REVISIONS			CITY OF RIVERSIDE, CALIFORNIA DEPARTMENT OF PUBLIC WORKS		
MARK	DATE	DESCRIPTION			
1	8-23-63	ALIGNMENT CHANGE A.W. CAP WORK	<b>EAST SIDE TRUNK RELIEF SEWER</b> STA. 0+00 TO STA. 14+00 1/2% BEGIN STEEL CONDUCTOR		
2	9-29-63	ADDED M.H. NO. 5 TO SEWER A.W. CAP WORK			
3	9-3-63	DELETED CONDUCTOR PIPE FROM STA 3+06 TO 3+10 CA			
4	12-2-63	CHANGED PL. GRADE FROM STA. 11+00 TO 11+07 TO PROP. M.H. DUE TO LOWERING OF ST. CHANGE UNDER 11' 8" TO 11' 0" A.W. CAP WORK			
DESIGNED BY	O.A.P.	SUBMITTED BY	W. D. DAVIS	APPROVED BY	PROJ NO 5040
DRAWN BY	A.F.V.V.	CHECKED BY	RECOMMENDED BY	DATE	5-17-63
				S-398	
				SHEET 1 OF 3

REVISIONS			CITY OF RIVERSIDE, CALIFORNIA DEPARTMENT OF PUBLIC WORKS	
MARK	DATE	DESCRIPTION	EAST SIDE TRUNK RELIEF SEWER	
1	12-2-63	CHANGED FL GRADES TO FIT GRADES OF ST. CASINGS AND TO PASS UNDER 20" WATER MAIN A.W. CAP ON ?	STA. 14+00% TO STA. 26+33.35%	
DESIGNED BY <i>ADP</i>			APPROVED BY <i>[Signature]</i> DIRECTOR OF PUBLIC WORKS	
SUBMITTED BY <i>[Signature]</i>			PROJ NO 5040	
DRAWN BY <i>[Signature]</i>			S-398	
CHECKED BY <i>[Signature]</i>			DATE 5-17-63	
RECOMMENDED BY <i>[Signature]</i>			SHEET 2 OF 3

DESIGNED BY <i>QAS</i>		SUBMITTED BY <i>William D

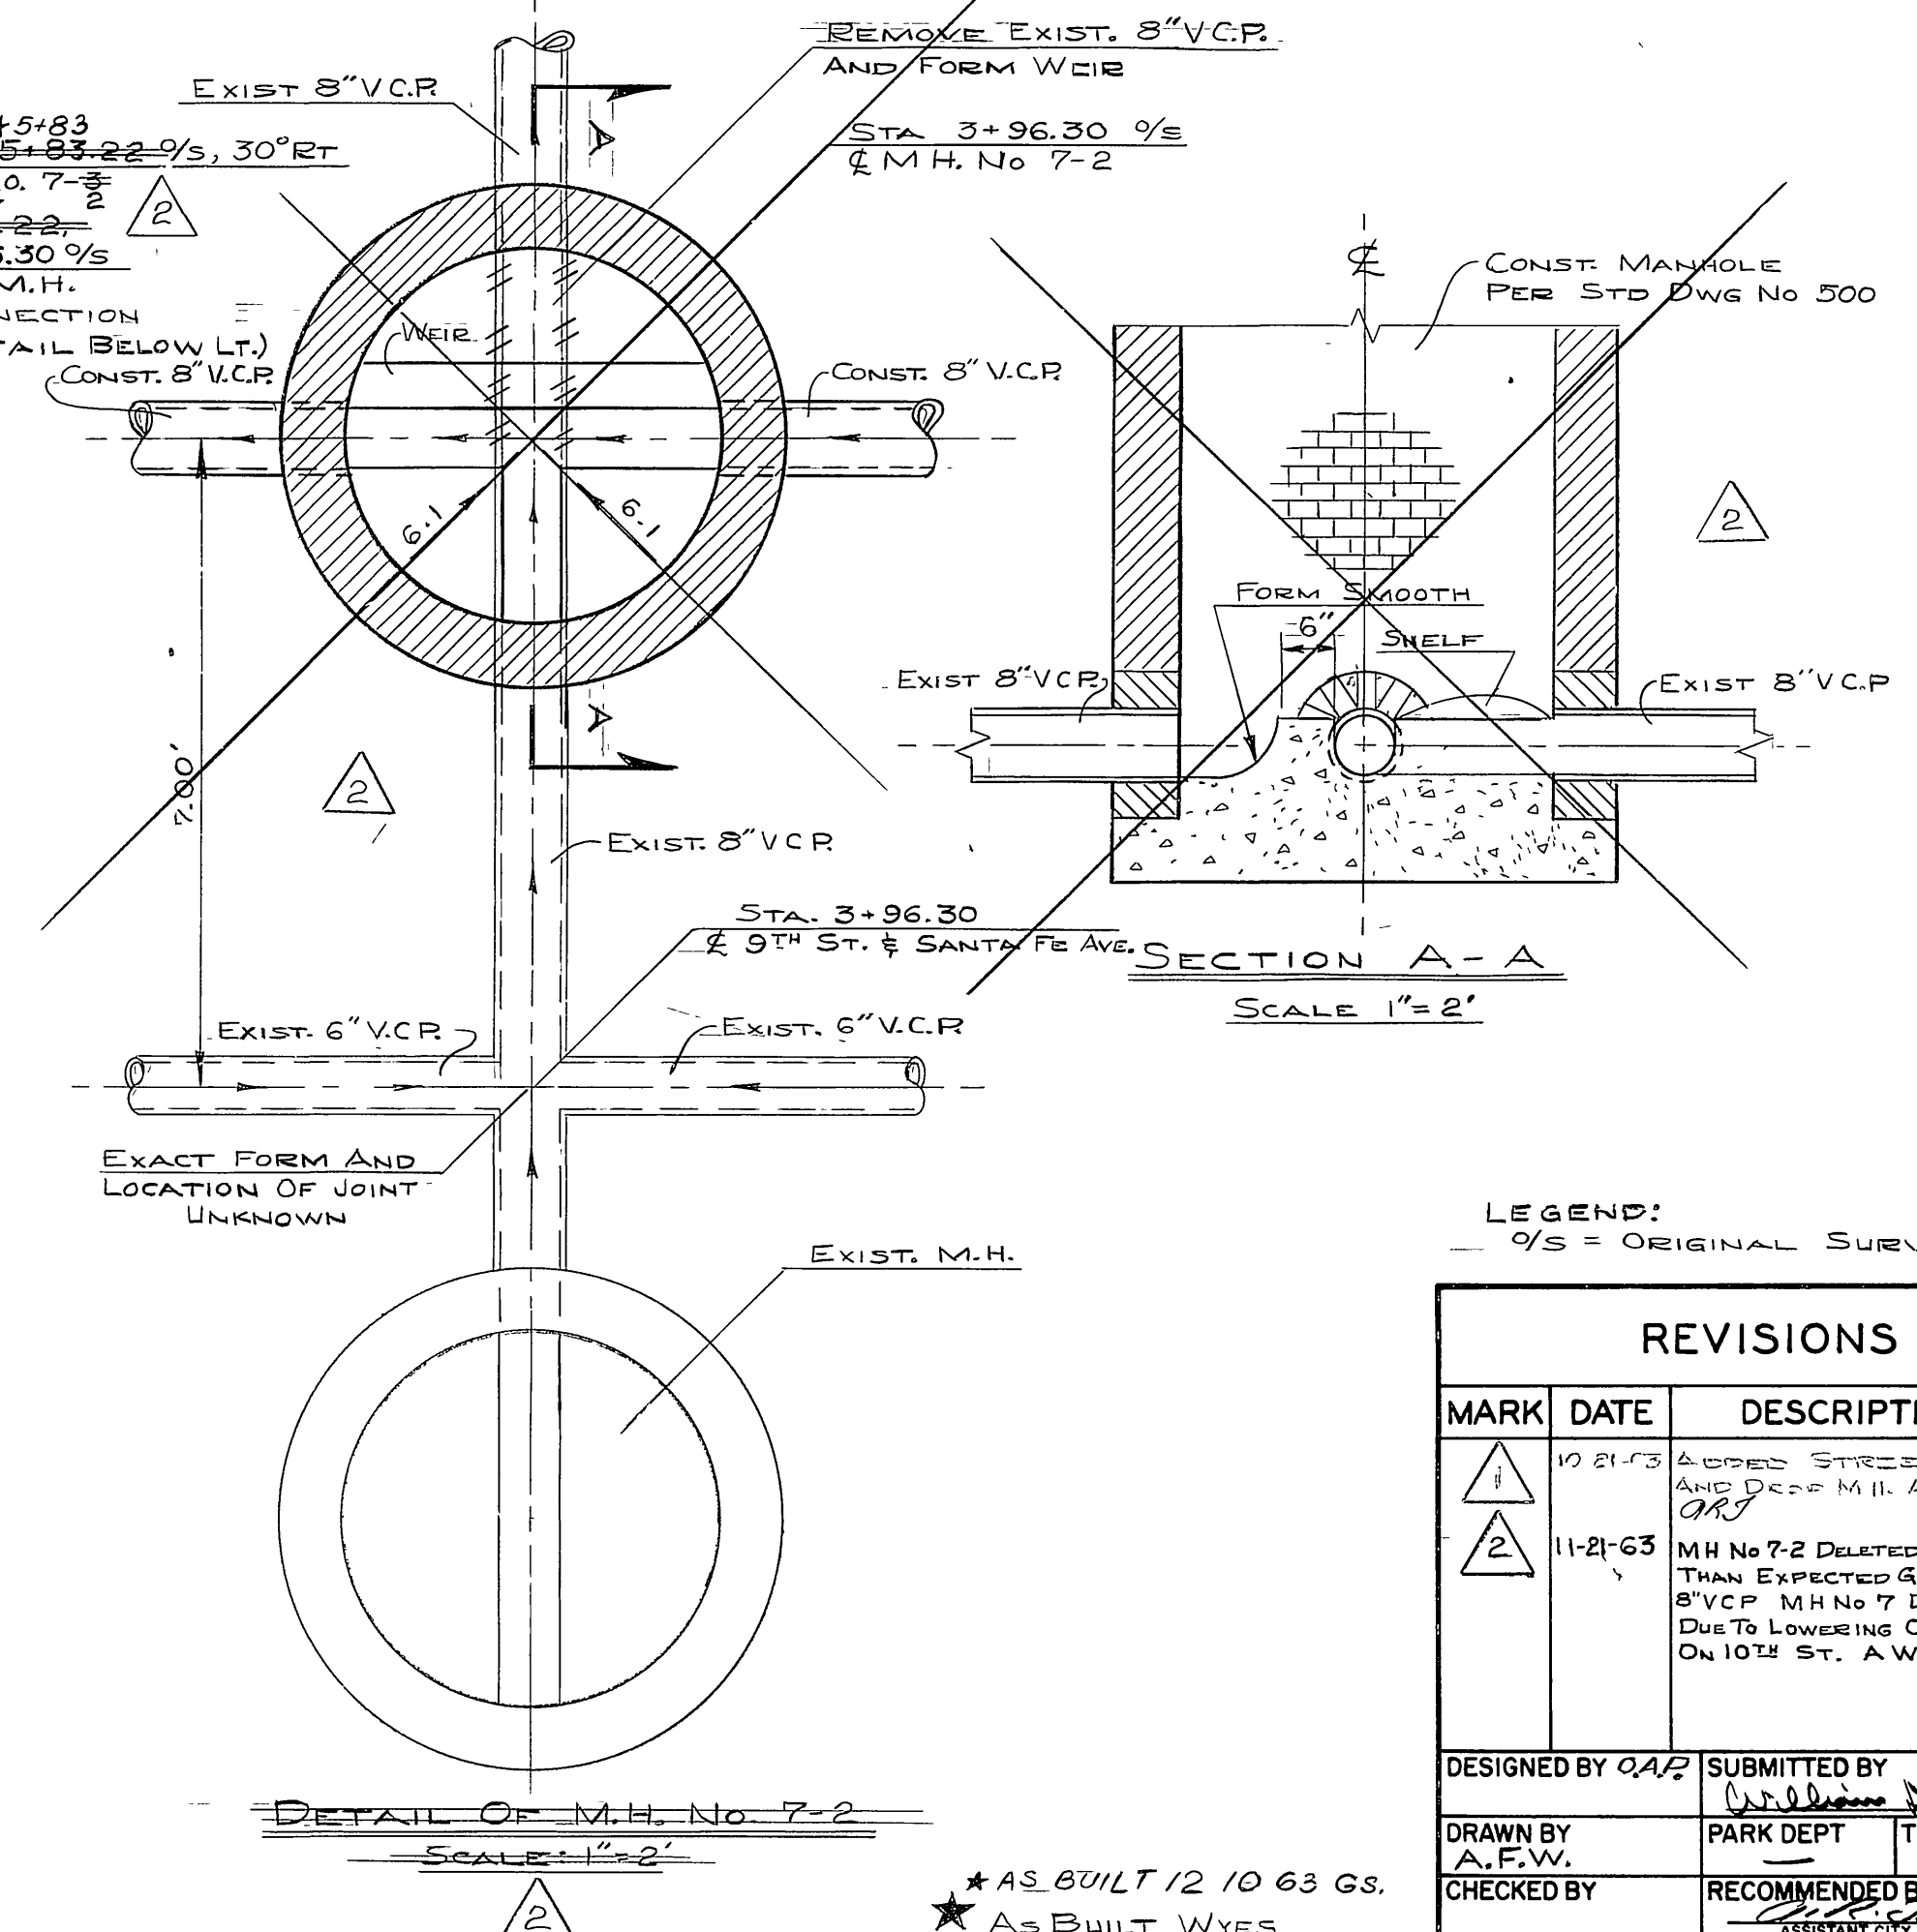
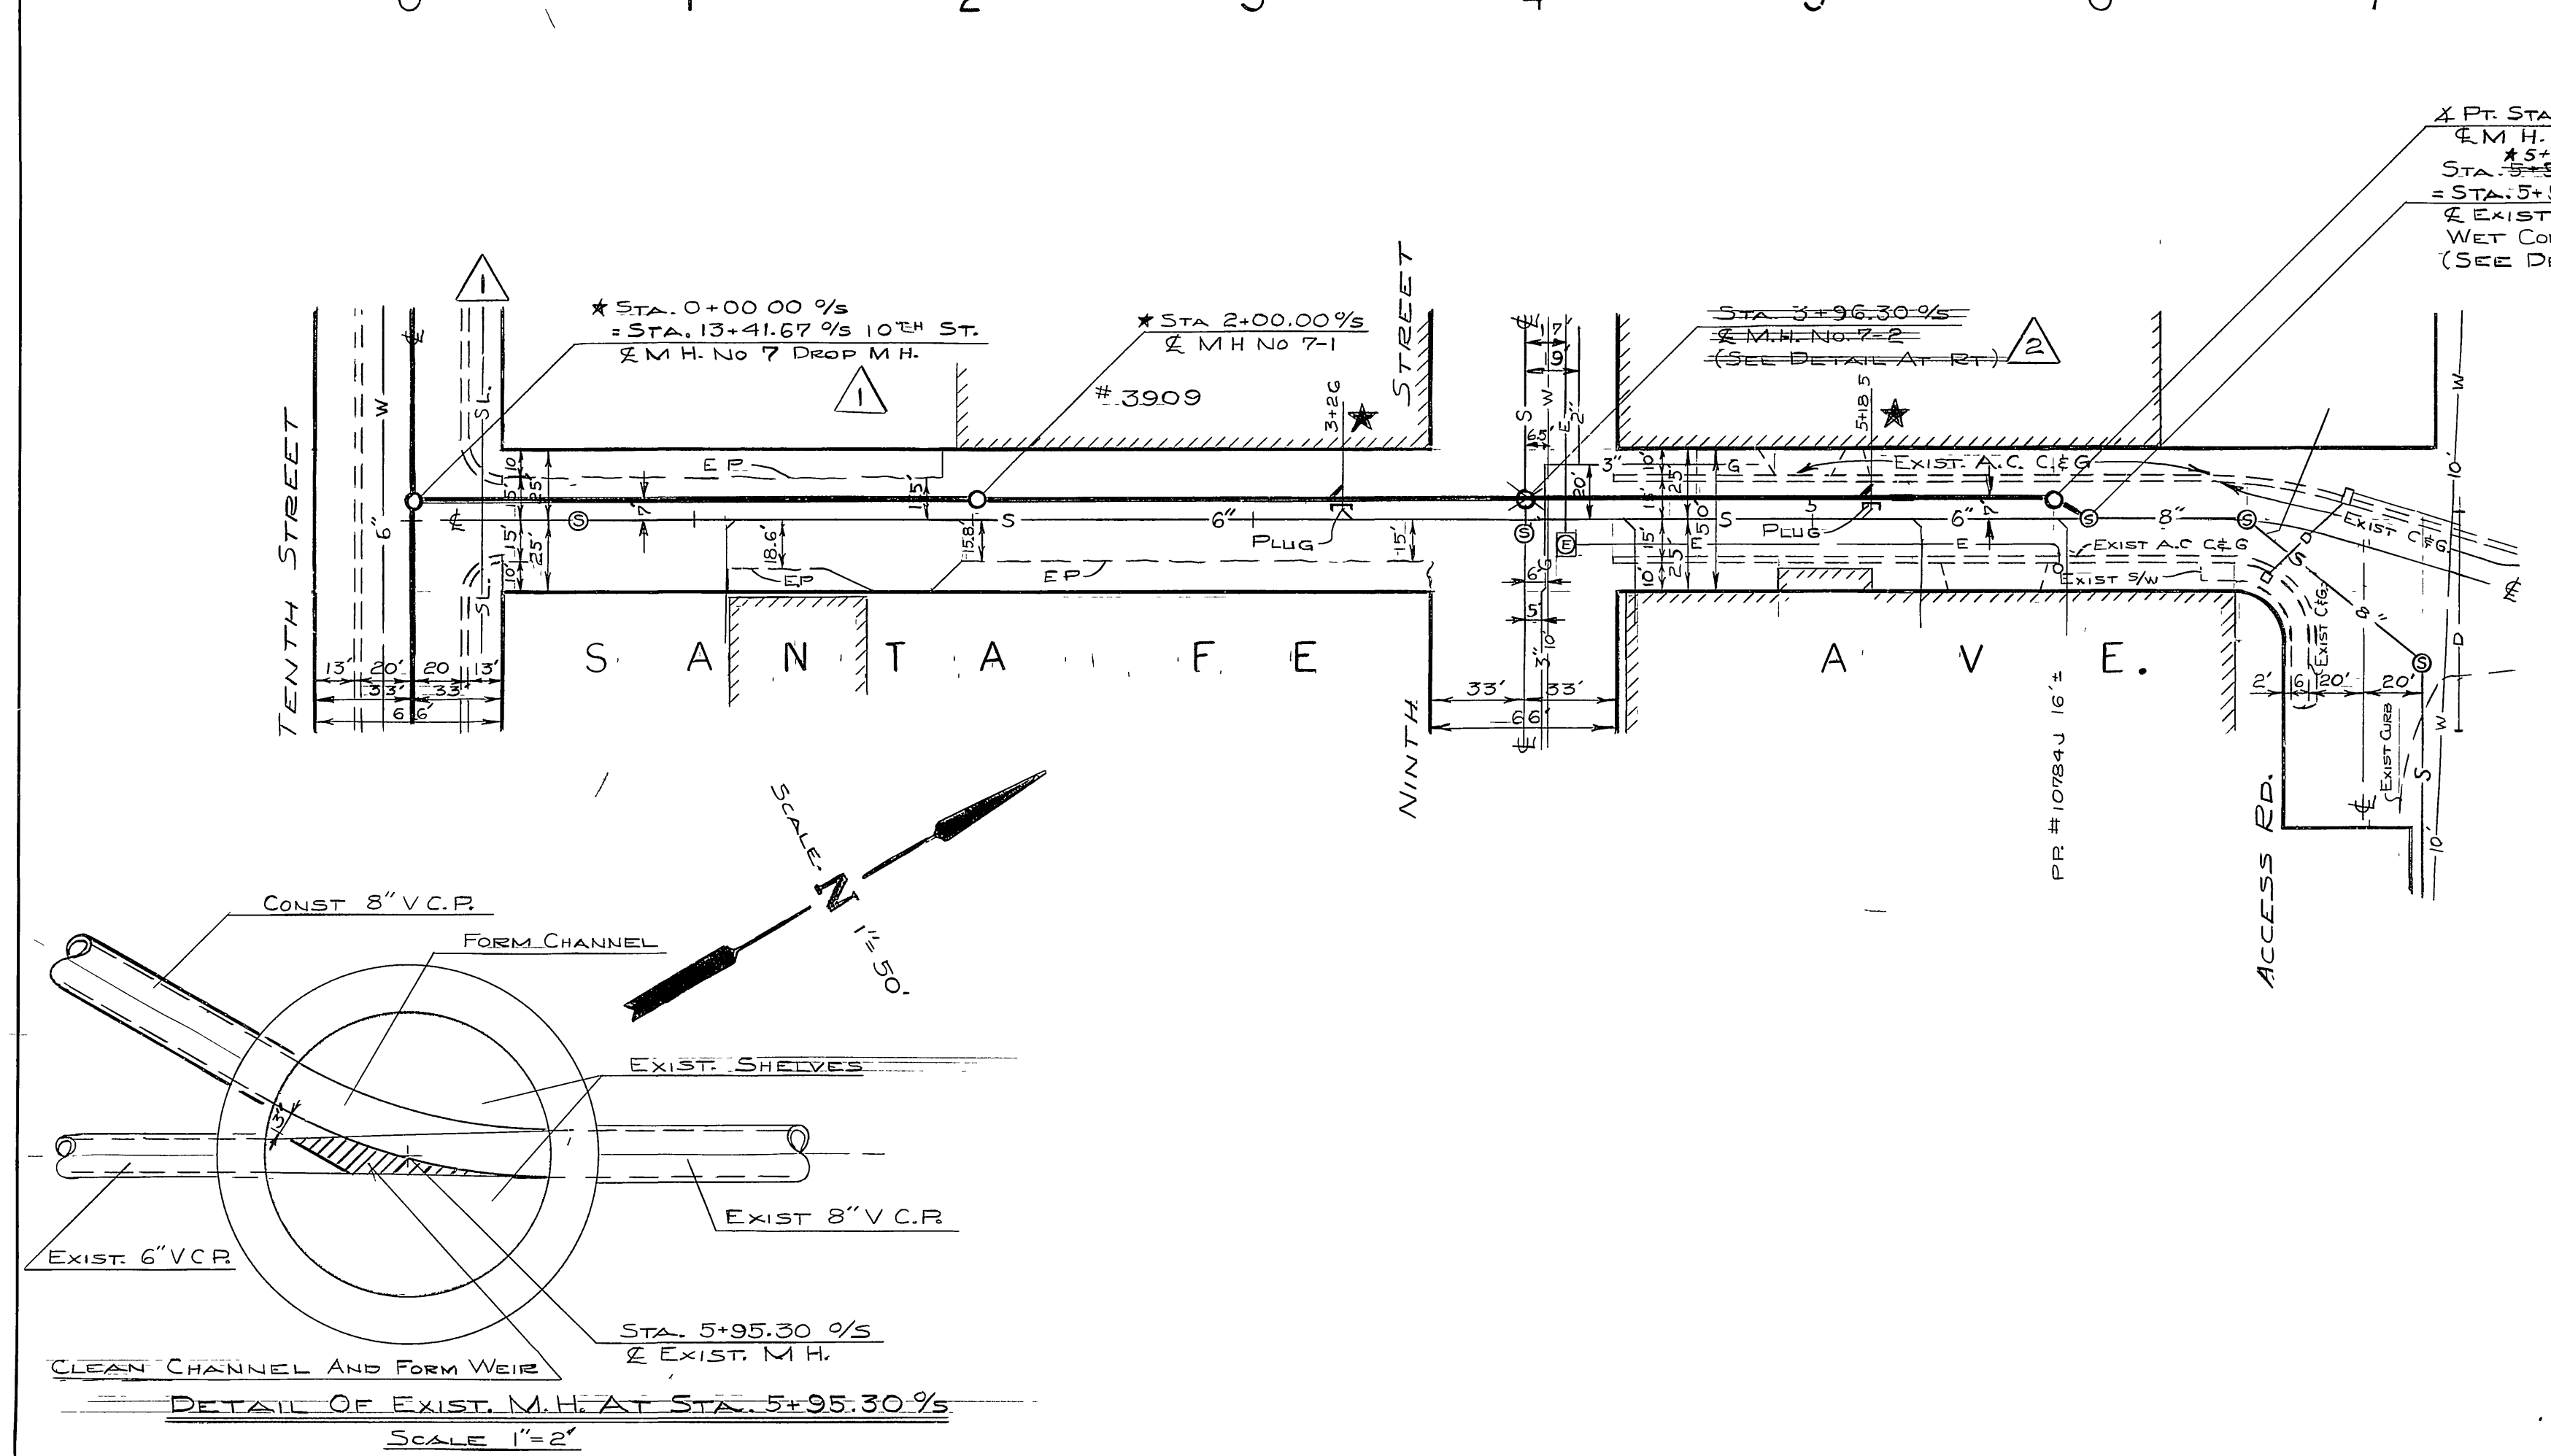
REVISIONS		
MARK	DATE	DESCRIPTION
1	10-21-63	ADDED STREET LINE SET AND DEF. M.H. A.W. O.A.P. OR
2	11-21-63	M.H. No 7-2 DELETED DUE TO LOWER THAN EXPECTED GRADE OF EXIST 8" V.C.P. M.H. NO 7 DROOP M.H. DUE TO LOWERING OF STL. CASING ON 10TH ST. A.W. O.A.P. OR
